Inspection Photos

API: 071-09838

Operator: WAPITI OPERATING LLC

Inspection Date: 5/3/2022

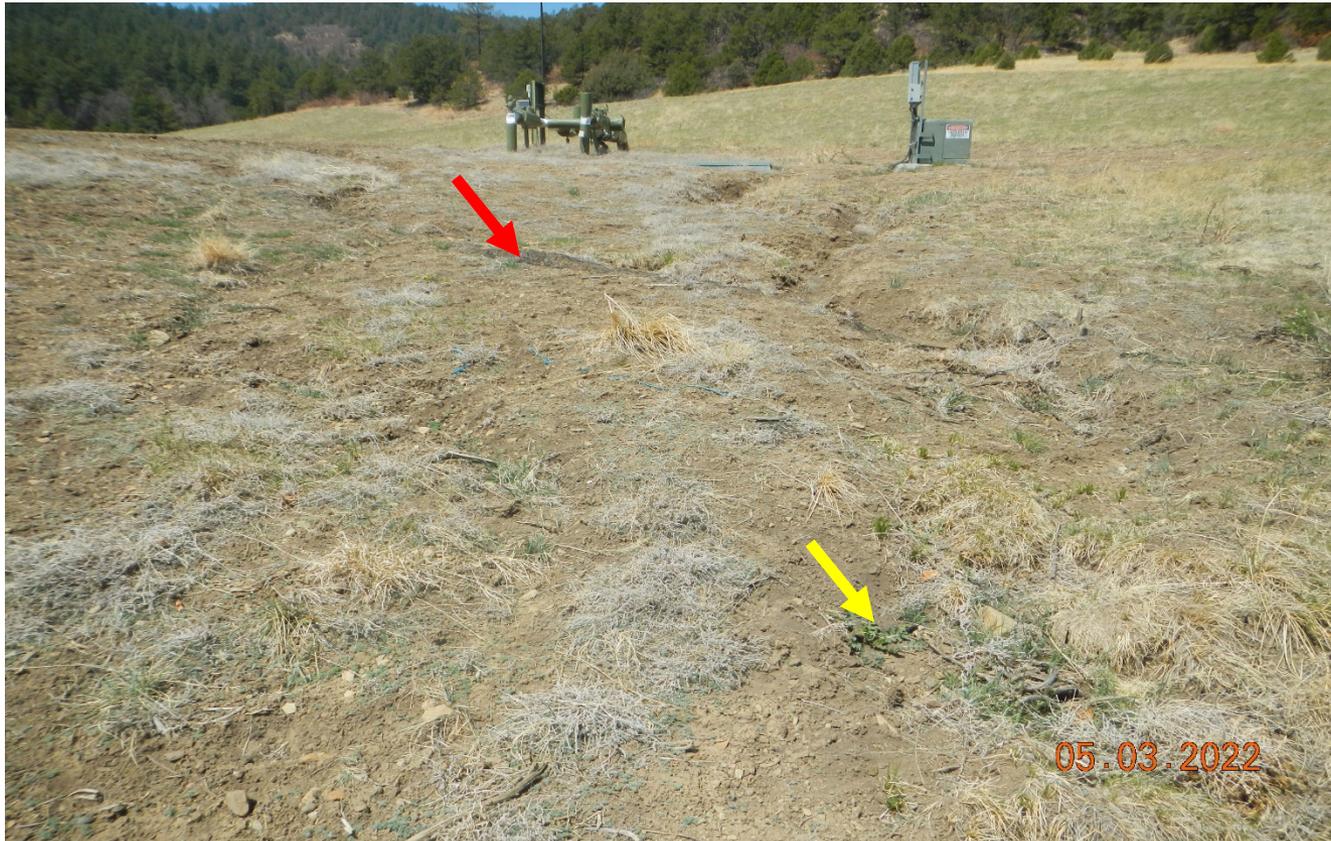
Photo 4. Facing toward the northeast side of the location. This area is not stabilized and there is an erosion. The wattles are degraded shown at red arrow. Previous corrective action not completed. There are noxious weeds beginning to grow (Yellow arrow – Musk thistle)
